## **TWO WAY CYCLING IN ONE-WAY STREETS**

To: Cambridge Joint Area Committee

Meeting Date: 23<sup>rd</sup> September 2014

Purpose: The Committee is asked to support signing and lining

PLAN 1 - PROPOSALS FOR BELGRAVE ROAD

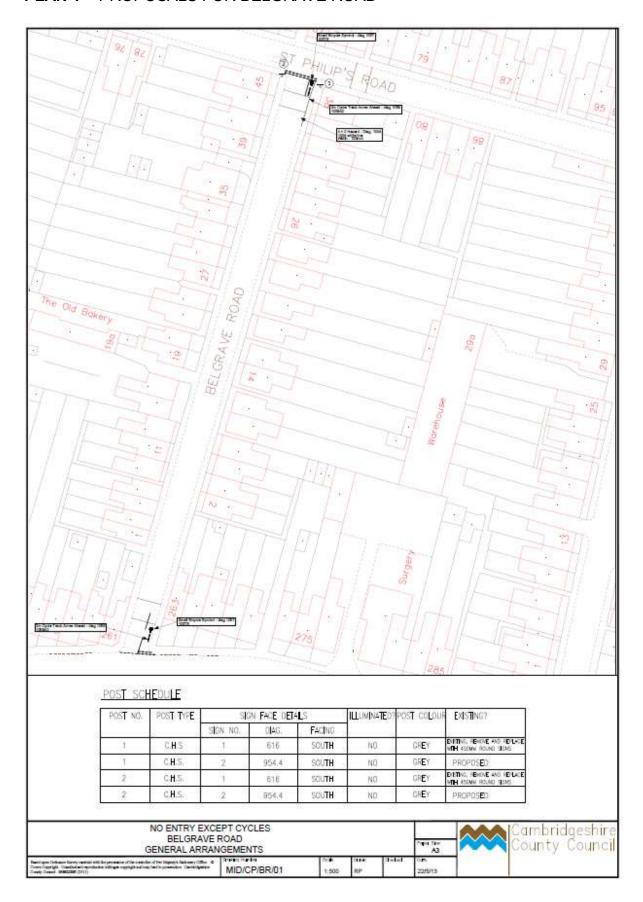
- 2.3 The proposed layout is shown on **Plan 1**.
- 2.4 There were two objections, and two responses in support. The objections relate to the cost and safety implications, particularly at the junction with Mill Road. There were no safety concerns raised in the road safety audit. This is

not a strategic route, but is beneficial to residents.

# PLAN 2 - PROPOSALS FOR MERCER'S ROW

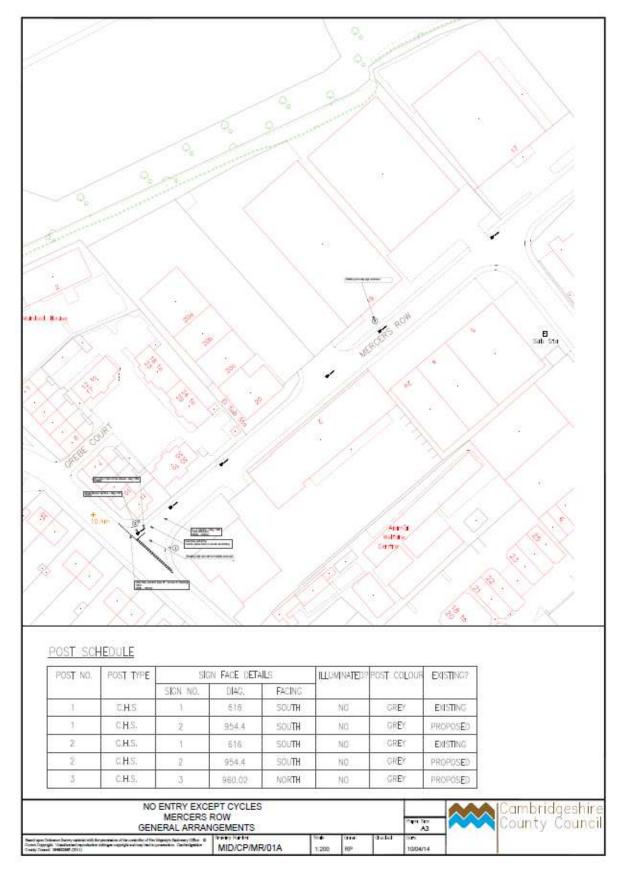
- 2.5 The proposed layout is shown on **Plan 2**.
- 2.6 There was one objection to this scheme which was concerned with risks posed by vehicles travelling the wrong way, and turning lorries.
- 2.7 The safety audit raised the issue of HGVs turning right at the junction with Garlic Row and conflicting with contra-flow cyclists turning into Mercers Row. It is felt that the red surfacing and marked cycle lane proposed at the junction will highlight the presence of cyclists sufficiently for this not to be a problem. Whilst this link will not provide an additional route for cyclists as it is not proposed to make Swann's Row two-way for cyclists due to safety concerns, this link will allow cyclists to access the traders on Mercer's Row and the children's 'funhouse' at the end of the road without having to make a long detour via Newmarket Road.

**PLAN 3 – PROPOSALS FOR PANTON STREET**

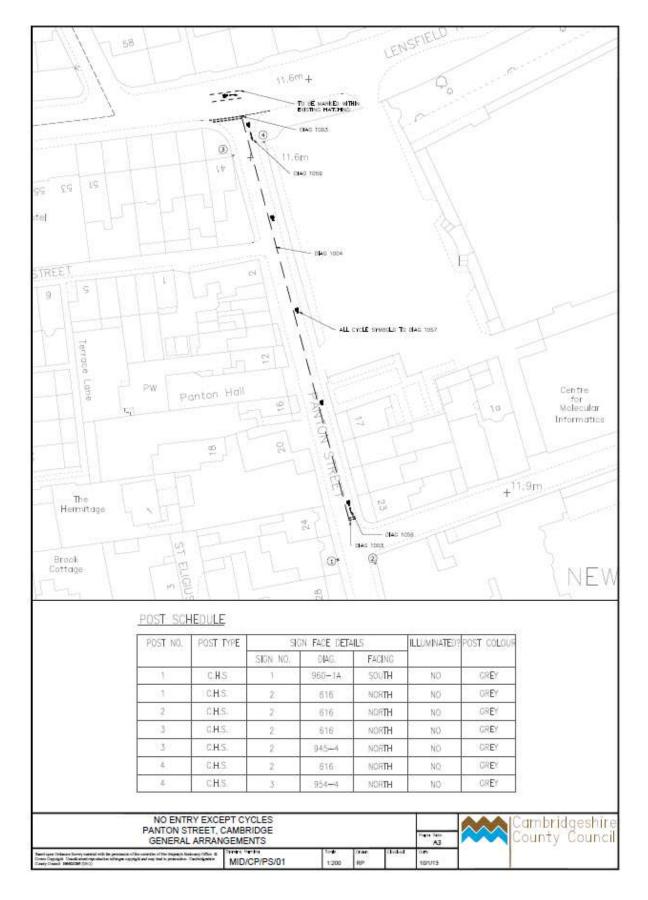
- 2.8 The proposed layout is shown on **Plan 3**.
- 2.9 There were five responses in favour of the scheme, including parents of children at nearby schools, and five against. Those against were concerned that cyclists would continue south beyond Union Road, that it was a waste of money and that traffic queues would lengthen. Some members of the North Newtown Residents' Association were also very concerned that reducing the traffic on Panton Street to one lane would significantly increase the queuing back from the junction with Lensfield Road.

- 2.10 The proposal includes the provision of a marked contra-flow cycle lane and so the with-flow traffic would be reduced to one lane. Some respondents in favour of the scheme asked that contra-flow cycling should be continued further to link to Pemberton Terrace or the whole length of Panton Street. It is felt that this is not safe due to the on street parking with relatively high traffic volume and speed. At the request of the safety audit the contra-flow cycle lane is proposed to continue into Union Road to emphasise that cyclists should not continue south down Panton Street.

- 2.11 Some observations were undertaken of traffic during the morning peak in May 2014 when the temporary removal of parking restrictions effectively reduced traffic to one lane. Some queuing was observed but there was no significant delay for motorists and the queue length did not go beyond Union Road. Turning movements were counted on one day, 4<sup>th</sup> June, and traffic modelling is being undertaken to ascertain the effect on queuing. It is anticipated that the results of this will be available to be tabled at the meeting.

PLAN 4 - PROPOSALS FOR ROSS STREET

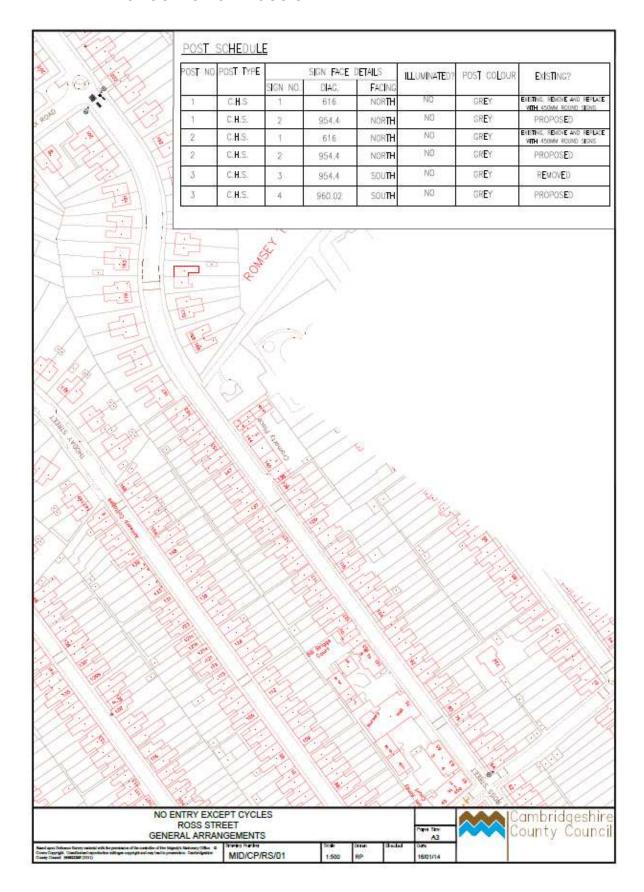
- 2.14 The proposed layout is shown on **Plan 4**.
- 2.15 There were five responses in support of this scheme (one with reservations concerning safety), and one response was concerned about the narrowness of the road and the possibility that parking would be removed.

- 2.16 The safety audit highlighted the narrow width of the traffic lane which does not meet their preferred minimum of 4 metres, and there was concern about the volume and speed of traffic which could result in southbound cyclists being squeezed between parked vehicles and passing northbound traffic.

- 2.17 Local Members and residents were keen to provide this very useful link to the park. It is felt that some cyclists would inevitably continue to St. Philip's Road and that it would be safer to allow this and warn motorists to expect contraflow cycles with signage. There are existing streets with similar widths and parking which are two-way for all vehicles, such as Ainsworth Street where there do not appear to be any problems, and there are sections of double yellow lines along Ross Street, between the parking, which cyclists could use as passing places. However, an alternative solution could be to have two-way cycling only as far as the recreation ground with no-entry signs at this point for cyclists.

PLAN 5 - PROPOSALS FOR SPRINGFIELD ROAD

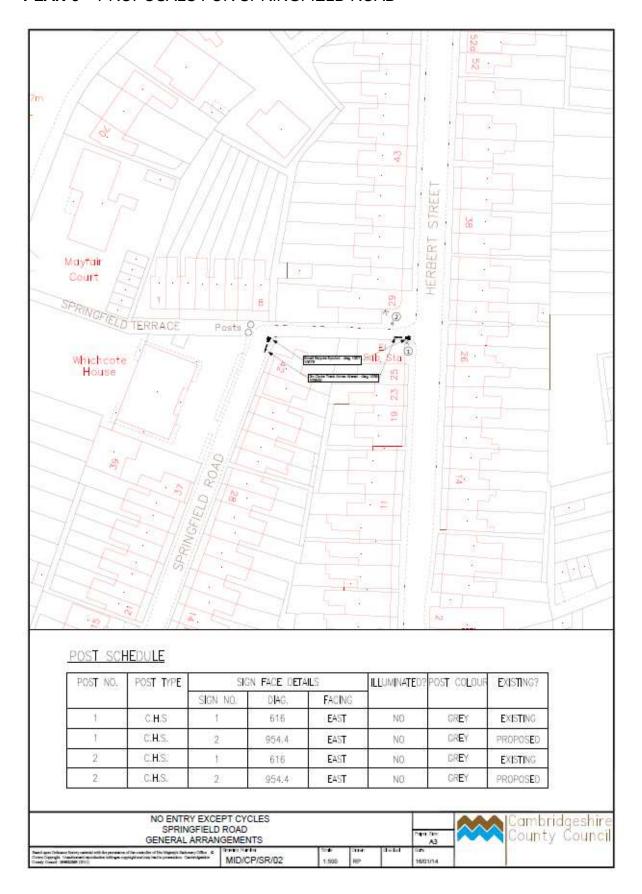
- 2.18 The proposed layout is shown on **Plan 5**.
- 2.19 There were three responses in support of this scheme (one with the proviso that the speed limit be reduced to 20mph), and no objections.
- 2.20 The safety audit expressed concern around this scheme due to the lack of visibility and narrow carriageway of the junction with Herbert Street, particularly where vehicles are turning right out as cyclists are turning in. However, it is felt that risk of an accident is very low given the low speeds and traffic flow at this location, and that the number of vehicles turning right will be very low as there is a dead end for motor vehicles at the Chesterton Road end of Herbert Street.

## PLAN 6 - PROPOSALS FOR TRAFALGAR STREET

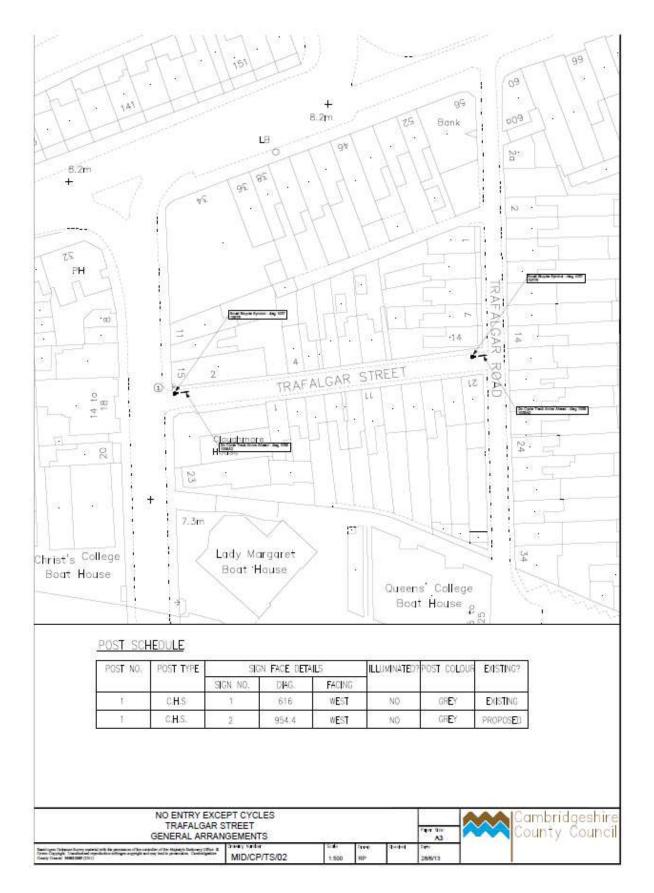
- 2.21 The proposed layout is shown on **Plan 6**.
- 2.22 There were no responses from the residents of Trafalgar Road. The scheme was requested by local members and a resident as a useful link avoiding Mitcham's Corner. The safety audit was not supportive of the scheme due to concerns about the narrow road width available where there is parking. Given the low speeds and traffic levels, and the fact that it means avoiding the need to cycle around Mitcham's Corner, it is felt that allowing the use of Trafalgar Road is an acceptable option.

**PLAN 7** – PROPOSALS FOR GARDEN WALK ('no entry' signs and 'except cycles' plates now not proposed)

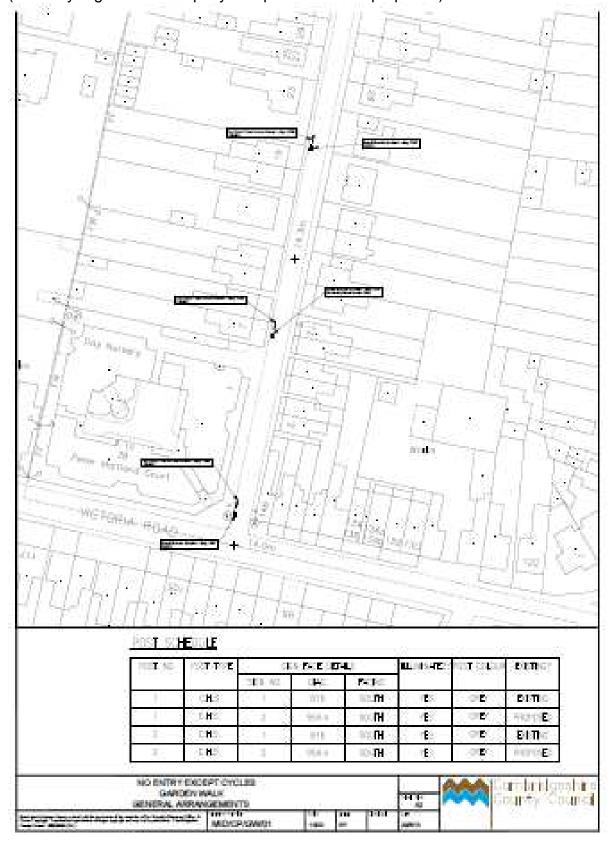
- 2.23 The safety audit raised concerns regarding the junction of Garden Walk and Victoria Road, and the proposal to introduce 'no entry' signs and 'except cycles' plates. Instead, and in response to local concerns, more signage will be erected in Stretten Avenue near its junction with Bateson Road to reinforce the 'no motor vehicles except access' restriction in place in the street, to allow enforcement and to reduce vehicle movements, and thus to make it safer for cycling. Road markings will be added to highlight the fact that two way cycling is already permitted in this street, with a 'plug' in place at the Victoria Road/Garden Walk junction.
- 2.24 The proposed layout is shown in **Plan 7**, though the 'No entry' signs and 'except cycles' plates have now been omitted.
